Review of NorthWestern's 2023 IRP

Michael Goggin, Grid Strategies

August 2023

Figure 1: NorthWestern’s claimed summer (left) and winter (right) net capacity in two docket²

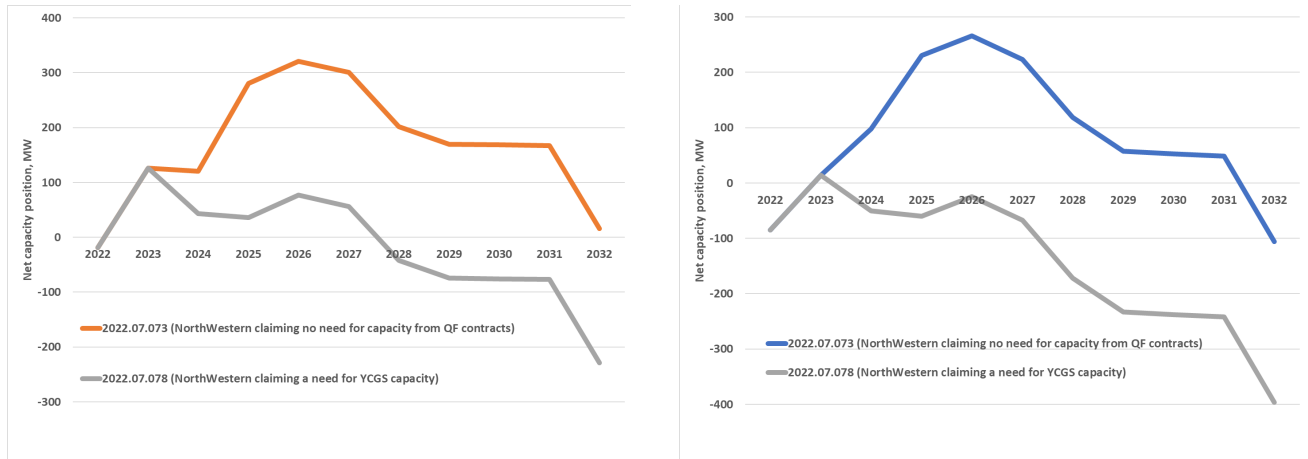
-NorthWestern has sufficient capacity for at least the next decade. NorthWestern's own charts in the IRP confirm that there is no need for additional capacity until 2032, and show a large capacity surplus in both winter and summer through 2028.¹ In other proceedings before the Commission, NorthWestern has confirmed its large capacity surplus in arguing that the avoided cost for capacity payments for Public Utility Regulatory Policies Act (PURPA) Qualifying Facility (QF) resources should be zero, on the basis that NorthWestern does not need additional capacity until 2032. As shown in Figure 1 below, NorthWestern has presented the Commission with drastically different views of its capacity position, depending on whether NorthWestern is proposing to add owned assets to its rate base (Docket 2022.07.078) or opposing QF resources on which it will not earn a rate of return (Docket No. 2022.07.073).

Figure 3: NorthWestern IRP chart showing ~100 MW drop in fossil generation as demand and prices spiked on December 22, 2022

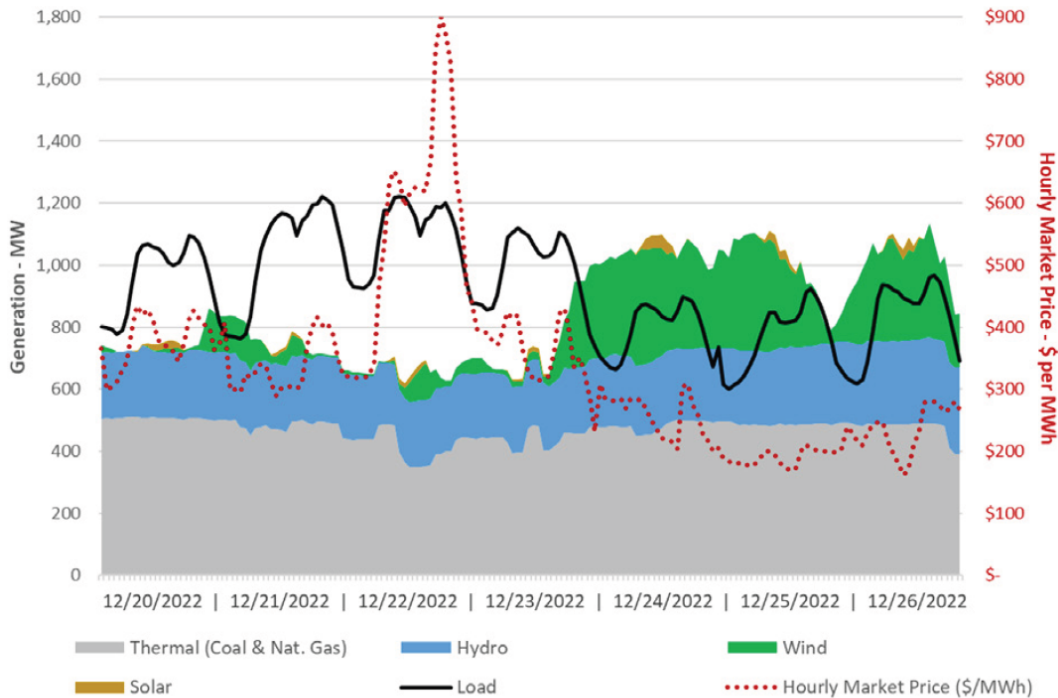
-NorthWestern ignores correlated outages that reduce the capacity value of fossil resources, and particularly gas generators. NorthWestern’s IRP claims that “NorthWestern is committed to the Colstrip acquisition and to completing YCGS. Both of those energy sources are proven to perform in extreme weather events and can be dispatched according to load and price signals.”¹⁹ However, the chart on the next page of the IRP, which is replicated below, shows a drop of around 100 MW in thermal generation (shown as the gray area at the bottom of the chart) during the peak demand and peak pricing period on December 22, 2022.

EPA hourly generation data indicates this drop resulted from the loss of nearly 100 MW of generation across units 1A, 1A, 3A, and 3B at the gas-fired Dave Gates Generating Station beginning in the late morning on December 22 and lasting until late that night,²⁰ as shown in the chart below. It is not clear if this drop in gas generation just as demand and electricity market prices spiked was due to an equipment failure, the loss of gas supply, or if gas spot market prices simply made fuel supplies uneconomic. Regardless, this event shows the reliability and economic risks of increasing NorthWestern’s dependence on gas generation, and directly contradicts NorthWestern’s claim that gas generators are “proven to perform in extreme weather events.”

Figure 5: DOE data showing NorthWestern demand and wind output on July 13, 2022

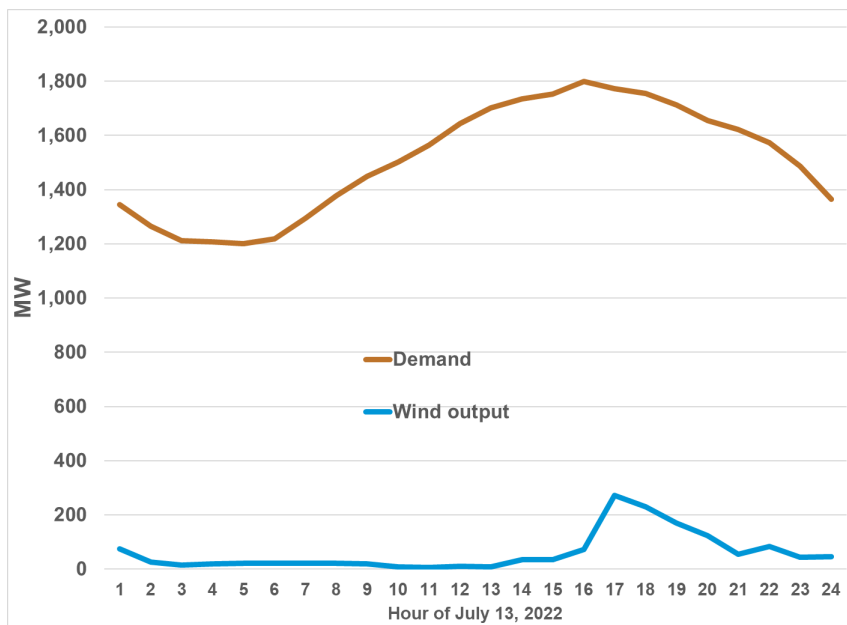
-NorthWestern overstates the challenges of accommodating renewables' variability. NorthWestern's IRP cherry-picks a single event during which wind output on its system was highly variable.²⁸ NorthWestern does not attempt to establish that this event posed a concern for reliability, and a cursory review of the data confirms that it did not. First, Department of Energy data show that the ramp up in wind output occurred as demand was ramping up in the late afternoon peak demand period, and then wind output ramped down as load was dropping off that evening.²⁹ Because the ramp in wind output was highly correlated with demand, it actually reduced net load variability on NorthWestern's system, reducing the

ramping required of other resources relative to what would have been required for demand alone. Second, wind energy forecasting accurately predicts changes in wind output up to several days in advance, so NorthWestern and other grid operators can plan market purchases and the commitment and dispatch of other resources around expected changes in wind output. Third, even in instances in which wind or solar output ramps increase net load variability, that impact is greatly mitigated through EIM transactions that tap into geographic diversity in both load and wind and solar output patterns across the West, reducing ramping needs by around 60%.³⁰
